PCN# 20140627001

**Wafer Diameter Change for Select DEF-EP Niche Devices in LBC3S Process at DL-LIN
Change Notification / Sample Request**

Date: 6/30/2014

Sample Product Shipping Label (not actual product label)

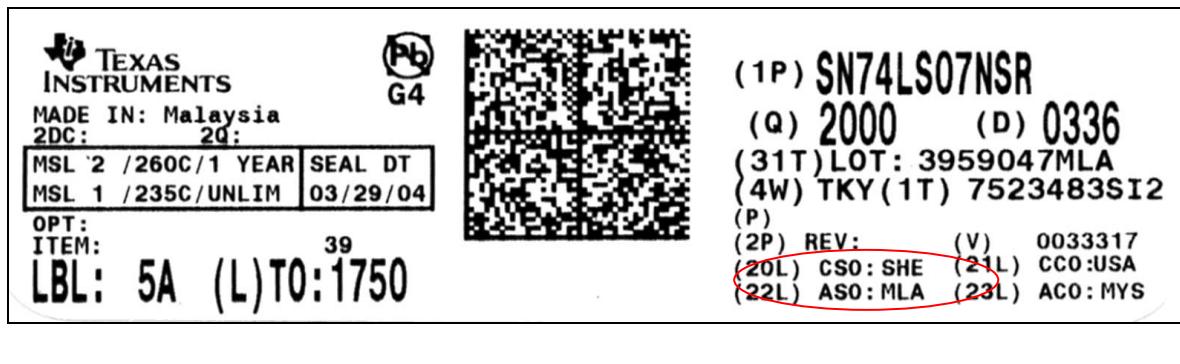
Changes to product identification resulting from this PCN:

Note: This is not a fab site change. No change to the Chip Site Location.

Chip Site	Chip site code (20L)	Chip country code (21L)
DL-LIN	DLN	USA
